MEMORANDUM

To: Kirkland Hearing Examiner
From: Tony Leavitt, Senior Planner
Jon Regala, Planning Supervisor
Date: June 10, 2020
File: DRV18-00312
Subject: **APPEAL OF DESIGN REVIEW BOARD DECISION
CONTINENTAL DIVIDE MIXED USE PROJECT
FILE NO. DRV18-00312**

PROJECT PLANNER: TONY LEAVITT, SENIOR PLANNER

ITEM 1 | SITE PLAN / LEVEL 1 FLOOR PLAN

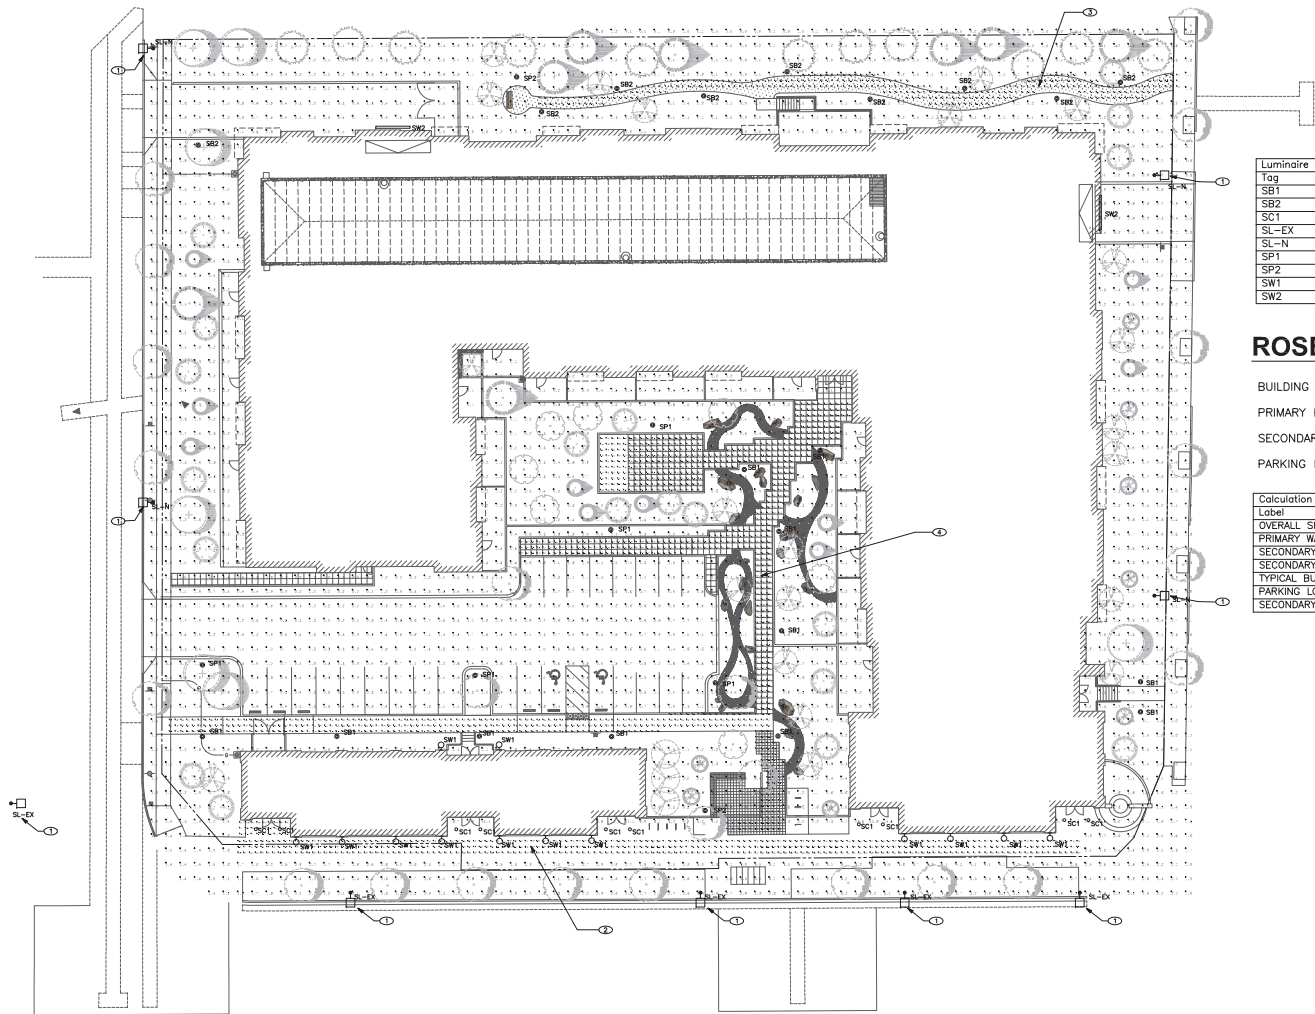
- Submit an updated formal setback modification request. The request should address the criteria in KZC Section 142.37.
 - a. Also include a site plan that highlights all the encroachments.

There were originally 4 Minor Variation Setback Requests (balconies facing 131st and 132nd, the NW driveway, and the buildings facing 85th Street). As shown by the red dashed line on the accompanying site plan, the balconies and driveway all comply with the prescribed setbacks and therefore no Design Departures or Minor Variations for these features are requested.

ITEM 4 | ELEVATIONS

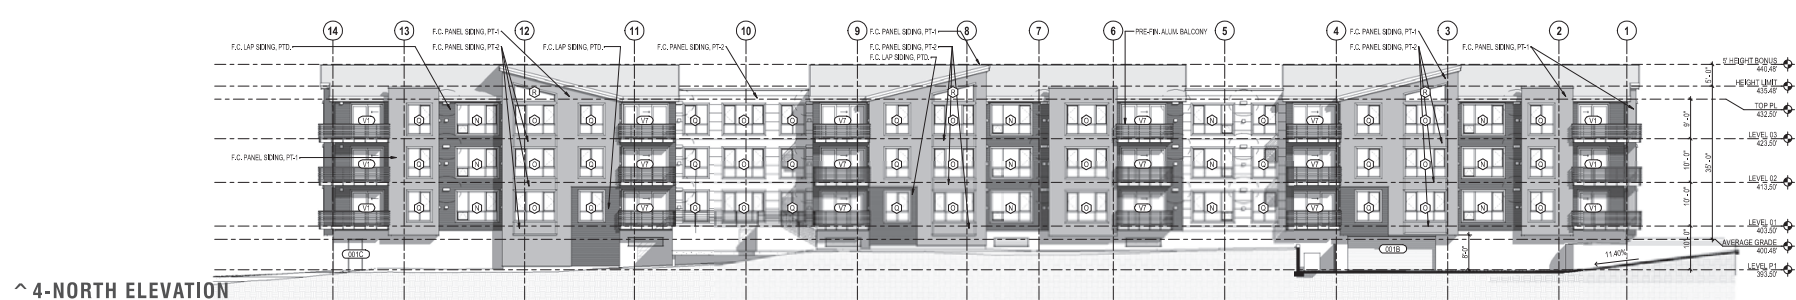
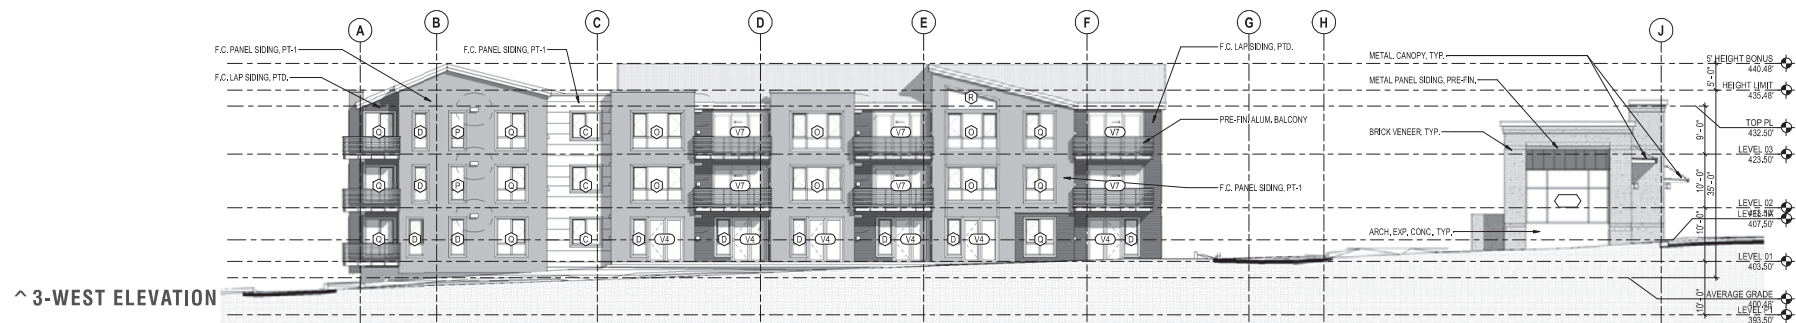
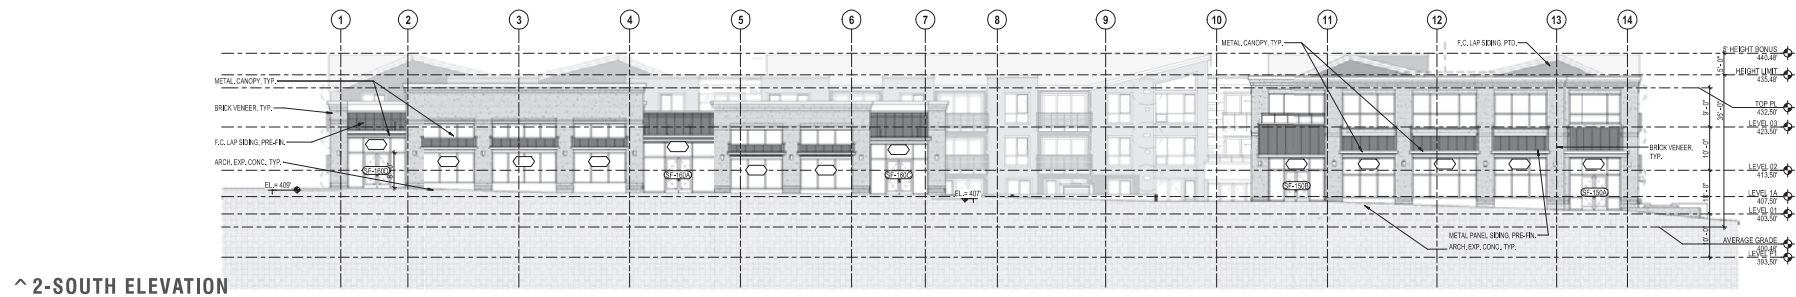
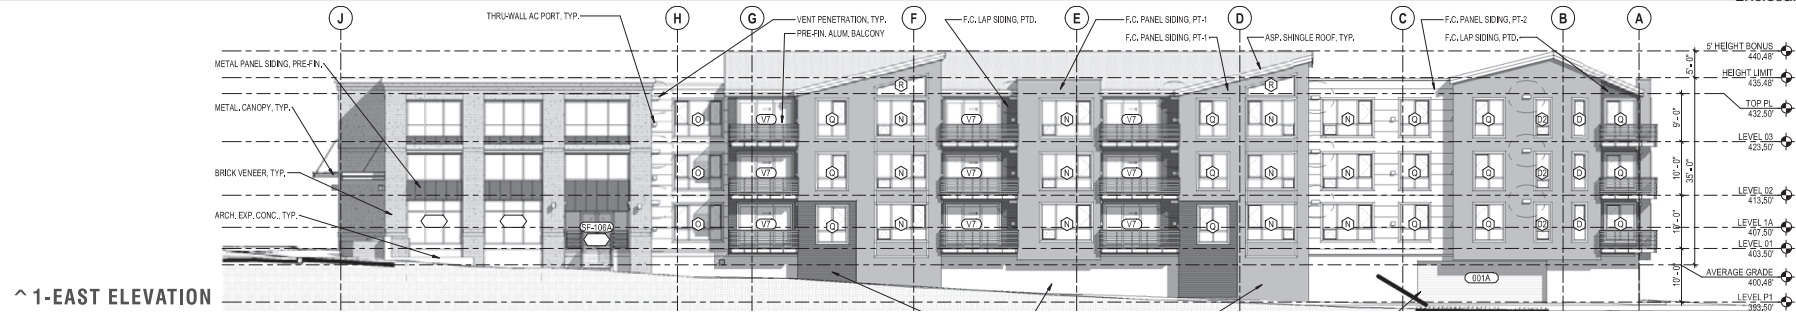
- Provide elevations for all facades for each building including the north facade of the standalone commercial building.
